Proposal for seeking prior approval of the Central Government under Section 2(ii) Sub: of the Forest (Conservation) Act, 1980 in favour of M/s Odisha Coal & Power Ltd (OCPL) for non-forestry use of 342.87 ha of forest land for development of Dip Side Manoharpur Coal Mining Project in Sundargarh District of Sundargarh Forest Division, Odisha - Compliance to GoI observations regarding.

Sub: Minutes of Meeting (MoM) of "Advisory Committee" (AC) meeting dated 14th November 2023 on Agenda No.10 - Forest Diversion Proposal of 342.870 ha of Forest land for development of Dip-Side Manoharpur Coal Mining Project in Sundargarh District of Odisha Coal & Power Ltd (OCPL), Bhubaneswar (Online Proposal no. FP/OR/MIN/37631/2018).

Note on review of 51.64 ha forest land requirement for external over burden dumping at Manoharpur & Dip Side of Manoharpur Coal Mine Project (Expansion of Manoharpur Coal Mine – 8.0 to 16.0 Million Te per Annum) of Odisha Coal and Power Ltd, Bhubaneswar

Review on Forest Land requirement for External OB dumping

Position of Forest Land (51.64Ha) in External OB Dump

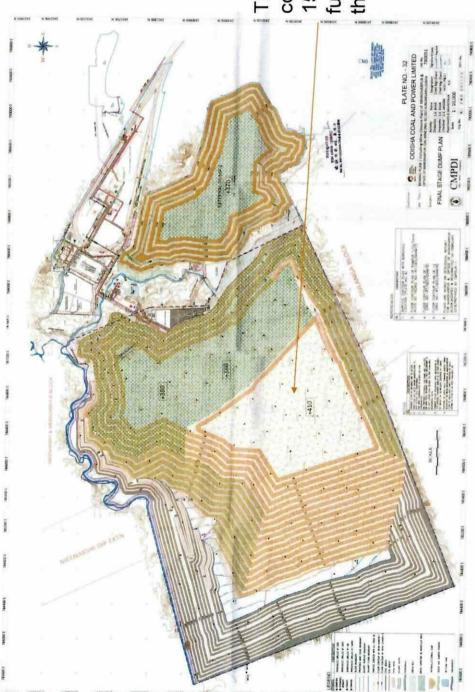
- xx. The State authorities recommended the proposal for diversion of 342.87 ha of forest land under FCA, 1980.
- xxi. As per the proposal 64.14 ha area has been proposed for Allied Infrastructure out of which 51.64 ha is for OB dump. The justification for proposing these non-site specific activities on forest land was asked and no satisfactory reply has been received from the State Govt.

- b) The forest land proposed for dumping is 51.64 Ha, which is a non-site specific activity and the same cannot be considered on the forest land.
- xxiii. As the UA has applied 342,870 ha forest land. Out of this proposed FL 10.52 ha will be used after 12 years and 166.06 ha will be used after 25th year and 51.64 ha will be used for dumping. In view of this scenario a huge patch of forest land sought for diversion does not seem to be utilized on urgent basis and in near future.

- 4. Decision of the Advisory Committee: After thorough deliberation and discussion with CF (FCA), GoO and DDGF (Central), RO Bhubaneshwar the Advisory Committee deferred the proposal with observations that as huge patch of the forest land i.e. 51.64 ha is proposed to be used for dumping which is a non-site specific activity, a detailed review is required from the state side.

External Dump-2 design	Rev-II (Earlier Plan)	Rev-III (Integrated Mine) Remarks	Remarks
Dump Area, Ha	175.57	230.80	Irregular shape is rectified to
Dump Height	30 to 80m (avg.60m)	120m	increase the dump height and
Quantity of OB, Mill. Cum	58.89	152.5	accommodate more OB in less area.
